RSB 559  
Nov 6, 2020

NHTSA #20V 594

## RECALL SERVICE BULLETIN

# Work Instructions for Front Jack Inspection and Repair

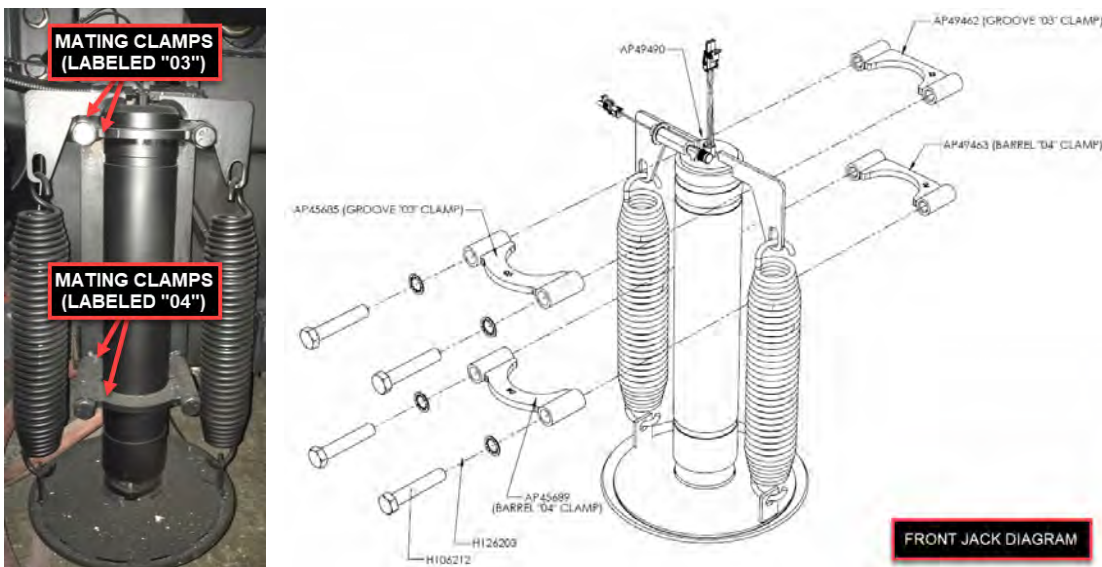
Place the clamps so you know where you took them off, and determine if the clamp was intended to be in the groove of the cylinder or on the barrel of the cylinder.

- Clamps labeled "03" are intended to be used in the groove of the cylinder.
- Clamps labeled "04" are intended to be used on the barrel of the cylinder.

The clamp halves must match for the intended position. Both upper clamps that fit in the groove must be 03 clamps, and both lower clamps that fit around the jack without the groove must both be 04 clamps.

If the welded half of the clamp is correct, then just the outer half brackets can be reoriented (mated) and reassembled.

The clamp half that is welded to the bracket could be wrong. If so, it will need to be cut off the bracket and a new, correct clamp welded back in its place. It is suggested to use a plasma cutter (if available) and grind smooth; otherwise, use another quality cutting device, and grind smooth in preparation of welding on new bracket(s).
